SAFETY RECALL BULLETIN

NHTSA RECALL 21V966

AUTOCAR, LLC SAFETY RECALL ACX-2109

Autocar has determined that a safety hazard may exist with certain left side drive Xpeditor® trucks equipped with a factory installed global positioning system (GPS) device. The GPS device can become detached, interfere with brake and throttle function.

Figure 1

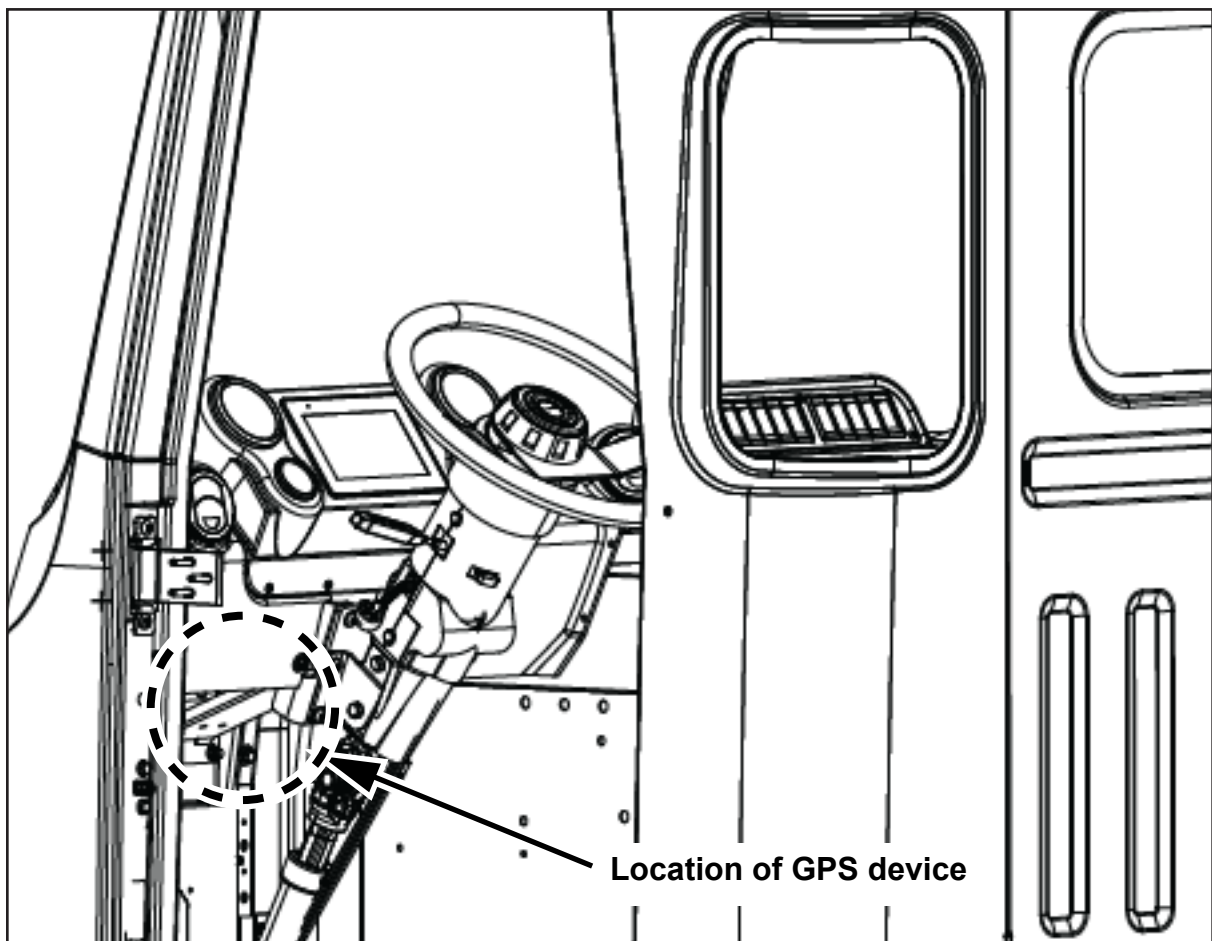
1. Follow all lockout/tagout procedures and verify the battery disconnect switch is in the “OFF” position.
2. Unlock and open the left door.
3. Locate the GPS device under the left side of the dash near the steering column (see Figure 1).

Figure 2

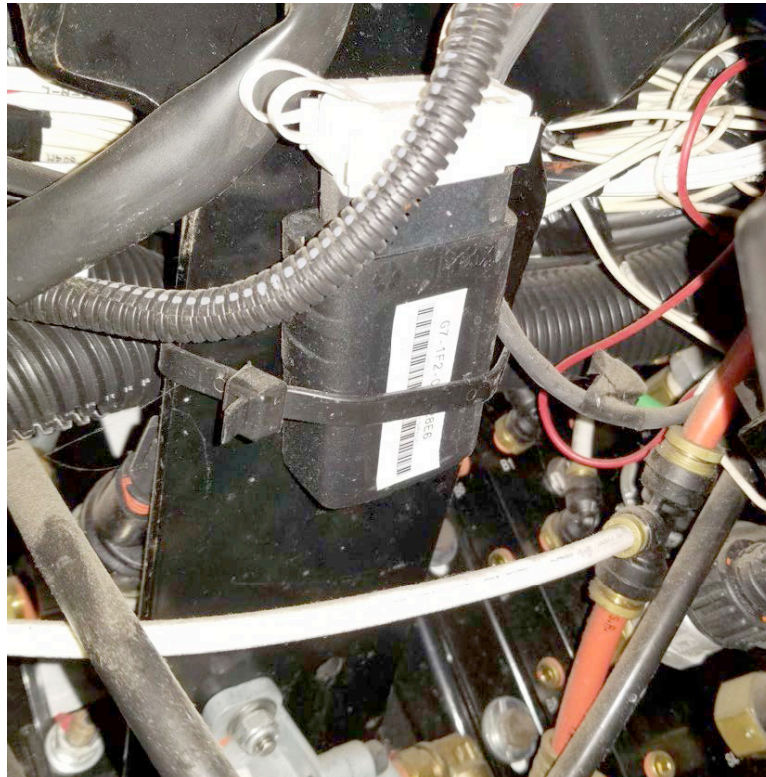
- Using a cable tie (obtain locally), secure the GPS device as shown. (see *Figure 2*).

- GPS device placement and securing is complete.
